**มอก. 1469– 2550**

**ECE Regulation No.26**

**03 series of amendments**

**VEHICLES WITH REGARD TO THEIR EXTERNAL PROJECTIONS**

Annex 2

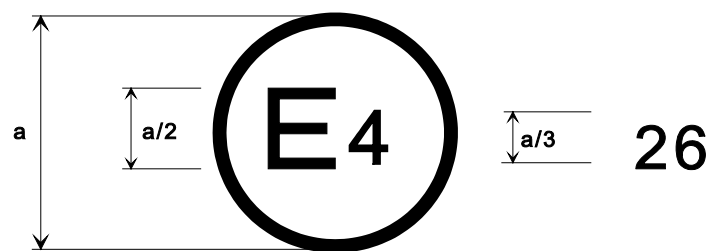
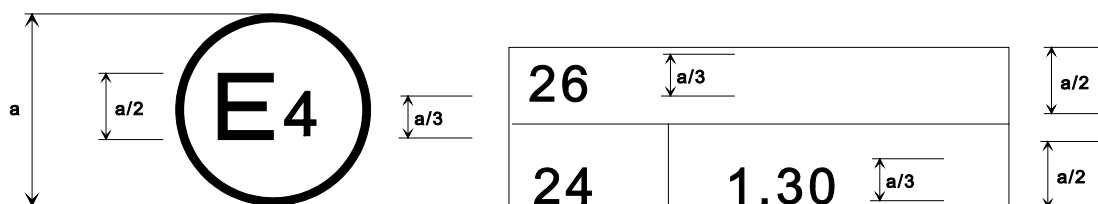
Replace Annex 2 by the following:

"Annex 2

ARRANGEMENTS OF APPROVAL MARKS

Model A

a = 8 mm min

The above approval mark affixed to a vehicle shows that the vehicle type concerned has, with regard to external projections, been approved in the Netherlands (E 4) pursuant to Regulation No. 26.

Model B

(See paragraph 4.5. of this Regulation)

a = 8 mm min

The above approval mark affixed to a vehicle shows that the vehicle type concerned has been approved in the Netherlands (E 4) pursuant to Regulations Nos. 26 and 24. \*/ (In the case of the latter Regulation the corrected absorption coefficient is 1.30 m<sup>-1</sup>.)

Model A

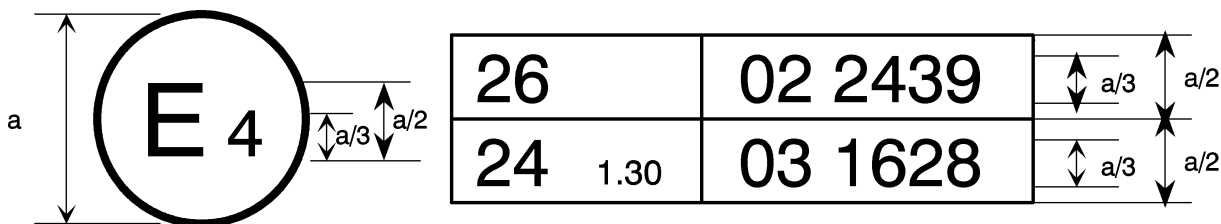
Model A of the approval mark, in the figure and in the caption below amend the number "02 2439" to read "03 2439" (twice). In addition, in the caption below the figure, amend the words "Regulation No. 26 included the 02 series of amendments" to read "Regulation No. 26 as amended by the 03 series of amendments".

Annex 2, replace by the following:

Figure 1 "

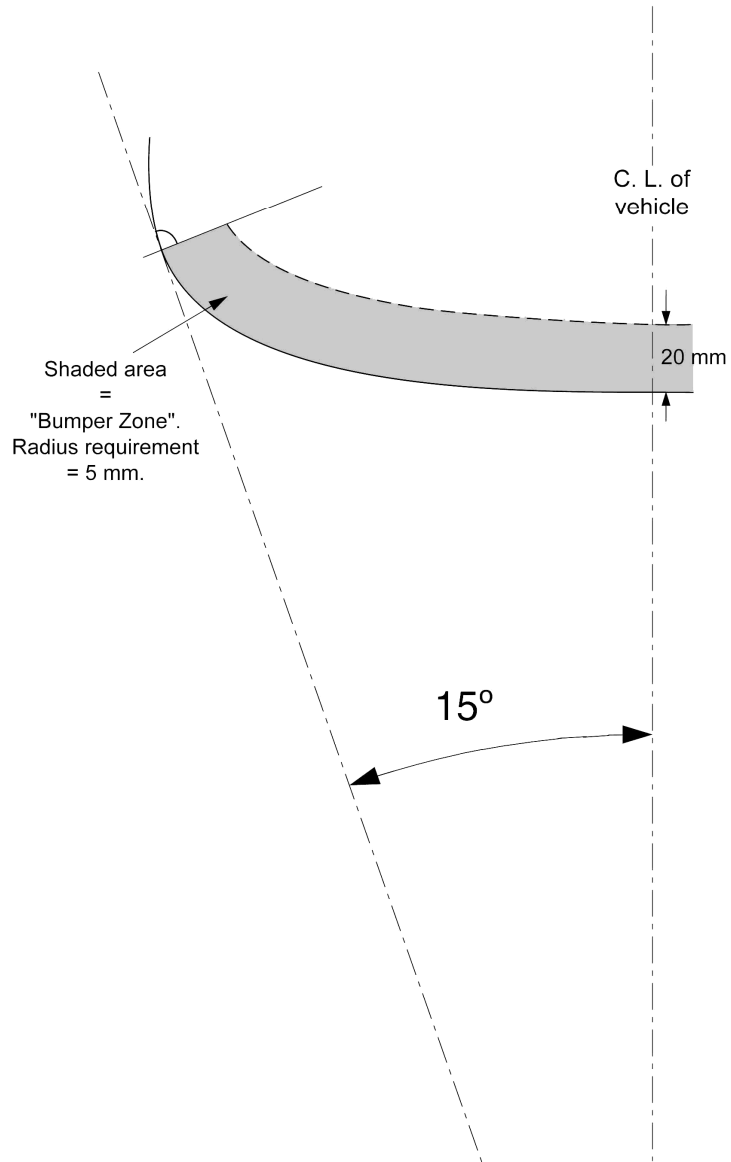
Paragraph 6.5.2., amend to read (including a new figure 1):

"6.5.2. If the line of the bumper which corresponds to the outline contour of the car vertical projection is on a rigid surface, that surface shall have a minimum radius of curvature of 5 mm at all its points lying from the contour line to 20 mm inward, and a minimum radius of curvature of 2.5 mm in all other cases. This provision applies to that part of the zone lying from the contour line to 20 mm inward which is situated between and in front (or rear in case of the rear bumper) of tangential points with the contour line of two vertical planes each forming with the longitudinal plane of symmetry of the vehicle an angle of 15° (see fig. 1).
